**TECHNICAL MEMORANDUM REGARDING PROPOSED CLOSURE OF
THE HAZELWOOD MINE AND POWER STATION, INCLUDING
FLOODING THE HAZELWOOD MINE VOID TO FORM A "PIT LAKE",
MORWELL, GIPPSLAND, VICTORIA, AUSTRALIA**

JULY 8, 2022

Figure 2: Hazelwood Project footprint (purple overlay) and surface extents of the proposed mine pit lake (blue line) flooded to +45 meters AHD (image from ENGIE’s 2021 EESRF). Note the locations of the HARA and other CCR landfills (e.g., HAP4) at the EOD east of the mine void.

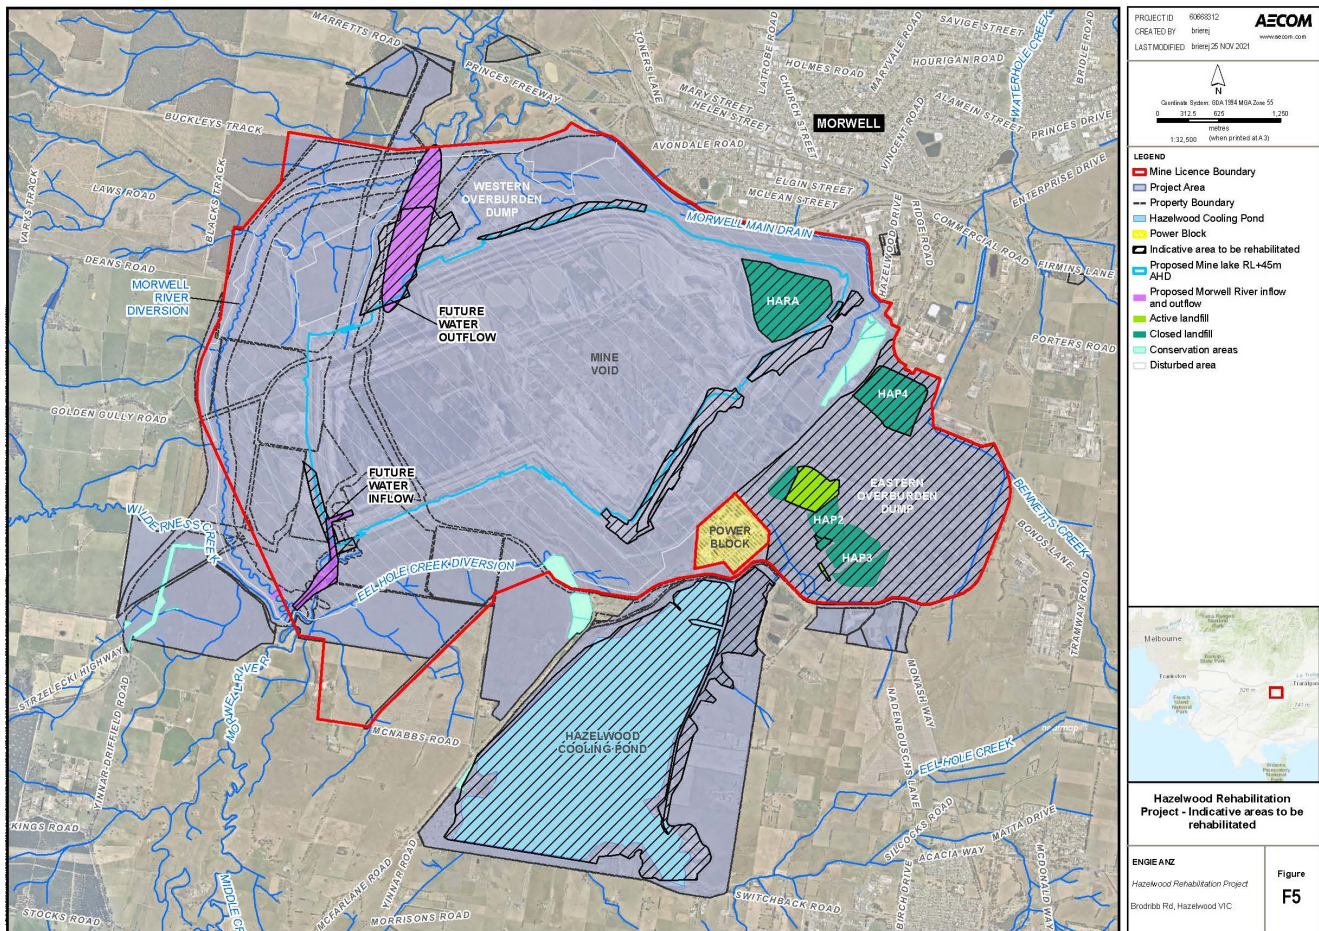
ENGIE's 2021 EESRF states, *"The proposed final landform for the former Hazelwood Mine void is a lake to a relative level (RL) of +45 metres Australian Height Datum (+45m AHD)"* (page 2), which equates to a maximum lake depth of 175 meters (Figure 2). The EESRF states that the Hazelwood pit lake will require approximately 637 GL (637 million cubic meters, m³) of water to reach the targeted fill elevation (page 6), but that volume ignores substantial ongoing water losses (e.g., evaporation or subsurface loss) that must be balanced in perpetuity. Estimates of fill time vary widely as a function of assumptions and scenarios, but I opine that the stated period of one or two decades

to fill the Hazelwood mine pit (e.g., EESRF, 2021, page 6) is more likely than not overly optimistic considering the many unknowns, including the likelihood of robust climate change which is likely to increase stress on water resources. ENGIE proposes to fill the Hazelwood mine pit using fresh water sources, but water availability depends on environmental impacts to be assessed via the EES and the Victorian government granting the necessary approvals to use fresh water for mine rehabilitation. I do not opine on the feasibility or appropriateness of using the limited water resources in this manner.

ENGIE's 2021 EES Referral Form (EESRF) does not identify the fate of CCRs and other wastes located within the Hazelwood mine pit (Figure 2). Impacts of concern to me include the mechanical stability of the HARA's CCRs (and any installed cap) during the erosive period of lake filling, maintaining indefinite stability once the coal ash is fully submerged (plus or minus periodic climate- or water management-driven reexposures), geochemical leaching of those CCRs to liberate toxic metals into the groundwater and lake water, and unrestricted migration of those dissolved toxins to other areas (e.g., via groundwater flow, the Morwell River, etc.). Approximately 80% to 90% of the CCRs produced at Hazelwood was fly ash (Fridell et al., 2019), a percentage that implies that fly ash comprises well over 1 million m³ of the 1.35 million m³ of HARA CCRs to be submerged. Much fly ash occurs as tiny, thin-walled, glass-encased bubbles called cenospheres (e.g., Joseph et al., 2013). This morphological type of coal ash has a density much less than water, so cenospheres have a strong tendency to float (e.g., [Cenospheres | ADAA | Ash Development Association of Australia](#)). I opine that breaching of the HARA from physical movements (e.g., settling and heaving of the underlying mine rubble) during or after mine pit filling and/or wave erosion during pit filling will more likely than not liberate cenospheres, and therefore a floating layer of coal ash may be prominent and persistent at the Hazelwood pit lake and its outfall(s) to other water bodies. Aqueous leaching of CCRs to liberate dissolved toxins to groundwater and surface water is addressed below.

Outside and east of the mine is the massive Eastern Overburden Dump (EOD; Figure 2) that hosts numerous CCR and industrial waste landfills (Figure 2). Mining wastes comprising the EOD also reportedly contains unknown volumes of admixed CCRs (AECOM, 2017). I opine that this occurrence of admixed CCRs at the EOD indicates that it is more likely than not that CCRs are also present inside the mine pit but outside the footprint of the HARA, and are most likely mixed to an unknown extent within two large "overburden" dumps (i.e., the Former East Field Internal Overburden Dump and the South East Field Internal Dump, EESRF, page 18). The EPAV considers these dumps as one "Internal Overburden Dump" (EPAV CUN, page 7, item 1.36), a general dump description used by others (e.g., AECOM, 2017; Weaver et al., 2019). Mined overburden materials and waste coal dumped inside the mine void would be fully submerged long before the pit lake is full. Physical destabilization (and geochemical leaching) of those dump materials during settling, wave erosion, mine floor heaving, and eventual land rebound are not addressed in the ENGIE reports and studies that I have obtained and reviewed to date. I opine that the omission of such assessments presents a significant gap in data and analysis that present potential for adverse impacts from ENGIE's mine pit filling plan.

Figure 3: Historic land surface subsidence (red) and projected rebound (blue) with distance from the Hazelwood mine (image from Waghorne and Disfani, 2019).

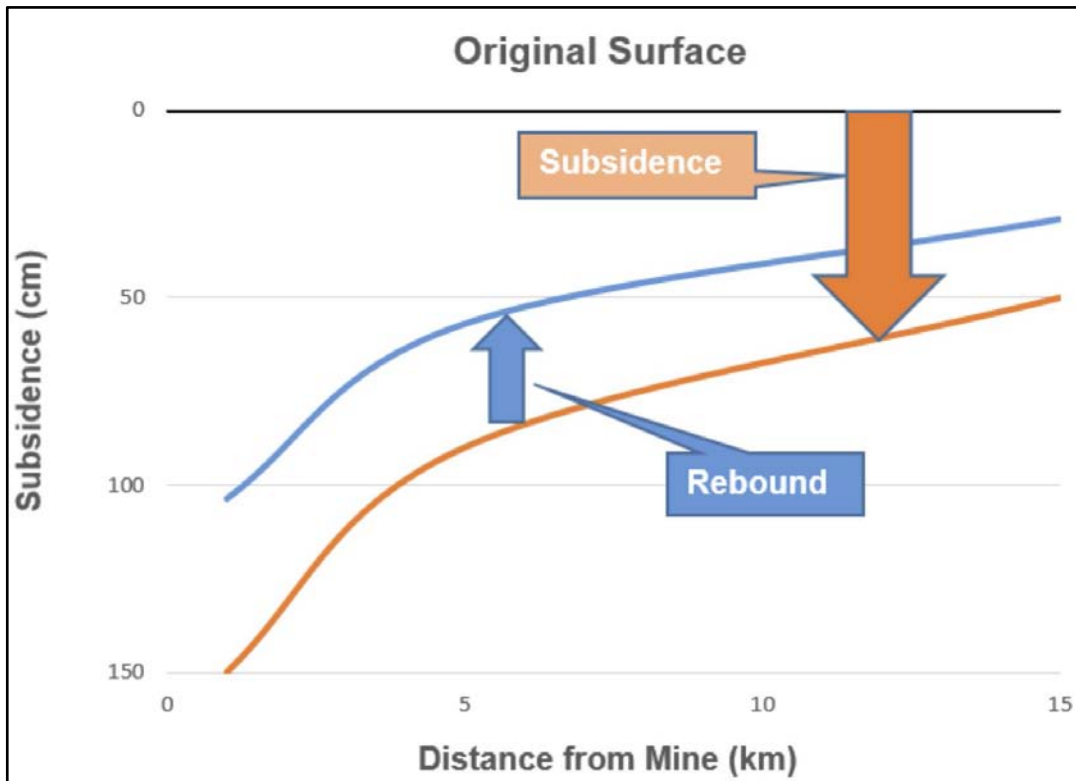
Decades of groundwater withdrawals from artesian aquifers for mine dewatering and other purposes has produced measurable land subsidence (surface elevation decreases) on the order of 0.1 to 2 meters across the Morwell area (Figure 1). Mechanical stability assessments of Hazelwood’s mine walls (batters) and mine floor during lake filling and projected land rebound (surface elevation increases) are focused on the impacts of swelling and heaving of *in situ* sedimentary materials

comprising the mine, including batters composed of lignite (brown coal) and fine-grained sediments (primarily clay) (Waghorne and Disfani, 2019; Simmons, 2020). Buttrressing of mine batters by added sediments and the mass of the pit lake’s water is projected to add stability to these inherently unstable features (Narendranathan et al., 2021). Approximately 25% to 40% of the historic subsidence (Figure 1) is projected to rebound (rise) over the next century (Waghorne and Disfani, 2019), with roughly 0.5 meter of rise projected at and near the Hazelwood mine (Figure 3).

Figure 4: Cross section of the HARA (from figure F11 in Appendix F of AECOM, 2017)

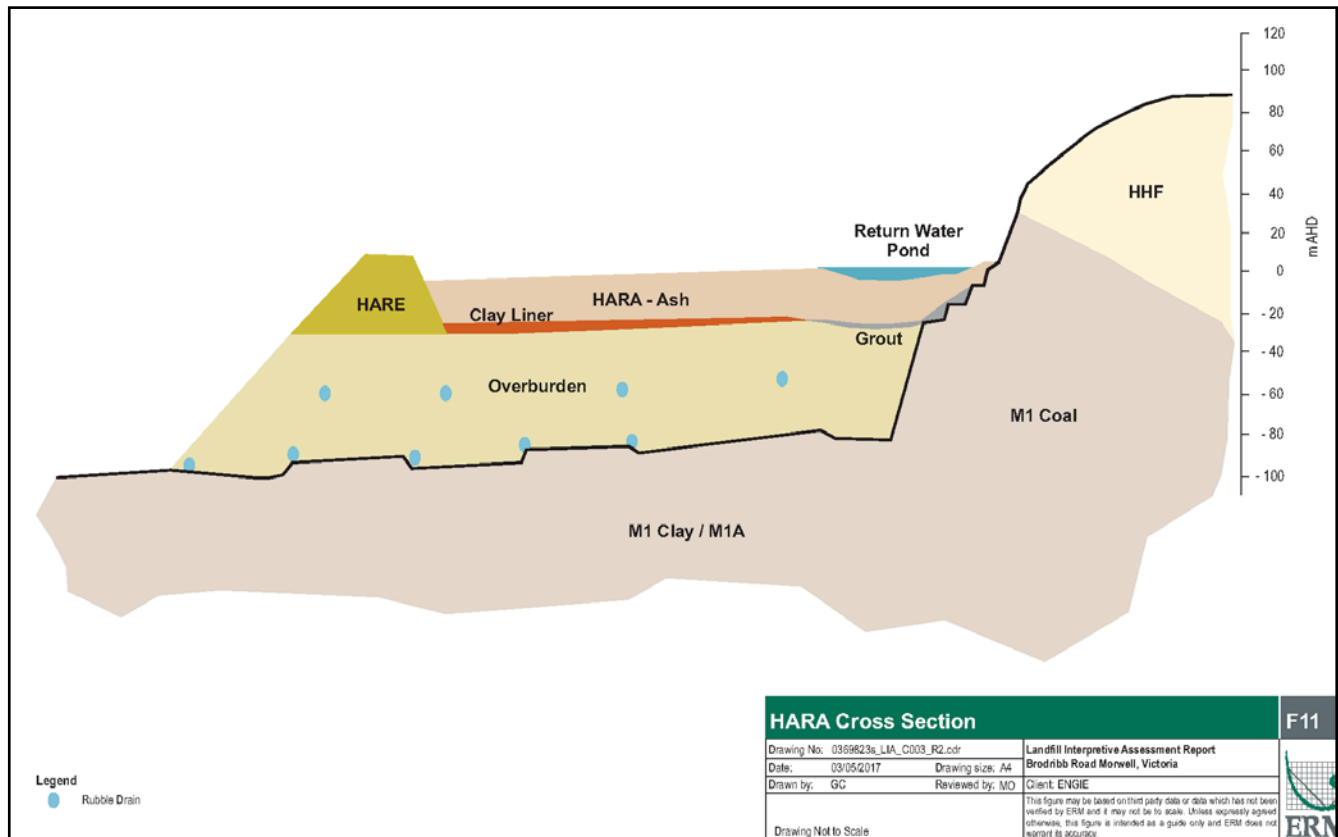
I have encountered no quantitative or qualitative assessment of the mechanical stability of disposed CCRs in the HARA (Figure 2), both during and after mine pit filling as the mine floor heaves and/or settles, and as the mine walls adjust (unevenly) to land rebound. The HARA is located atop 50 meters of unconsolidated overburden filling part of the mine pit, and a one-meter clay layer separates most of the CCRs from the underlying rubble (Figure 4). The northern margin of the HARA is the mine’s “Northern Batters” that partially failed in 2011, and those batters are a known concern for future stability of the mine and the adjacent Princes Freeway (Narendranathan et al., 2021). Construction of the 1-kilometer-long retaining dam (HARA Embankment; aka, HARE) forming the western boundary of the HARA and “multiple areas” of the HARA clay layer were not in compliance

with the construction plans (AECOM, 2017, page 12). Specifically, the clay “liner” is not considered “adequately constructed or wasn’t constructed in accordance with the Construction Quality Assurance Plan” (AECOM, 2017, page 12). ENGIE has not evaluated or expressed concern for the mechanical stability of the HARE or the HARA’s apparently defective “liner”, including uneven settling of the unconsolidated rubble of mine wastes underlying those structures (Figure 4). I have noted previously that the HARA’s “liner” does not comply with EPAV standards (Campbell, 202b). Likewise, ENGIE has provided no descriptions of proposed construction, appropriateness, and stability of any presumptive EPAV-compliant cap for the HARA, including during and after pit filling.

ENGIE’s projected pit lake surface elevation is +45 meters Australian Height Datum (AHD; i.e., mean sea level), and CCRs in the HARA will be fully submerged at +19 meters AHD, long before the pit lake is full. My concerns for stability of the HARA include impacts from settling, heaving, swelling, and/or rupture of the existing clay layer and any presumptive cap components as the zone of water saturation migrates upward into the HARA. I have similar concerns for the HARE due to potential settling and heaving of the underlying mine wastes, as well as the fact that the northern end of the HARE abuts the “Northern Batters” (Narendranathan et al., 2021). Swelling of currently dry CCRs

containing slurry muds and slimes within the HARA may produce additional instability within the stack of disposed CCRs and any overlying cap. ENGIE has not acknowledged potential physical impacts on the HARA of wave erosion during pit filling, and the only references to erosion at Hazelwood during filling concern shorelines of the mine void at the reshaped mine batters (e.g., EESRF, 2021, page 8).
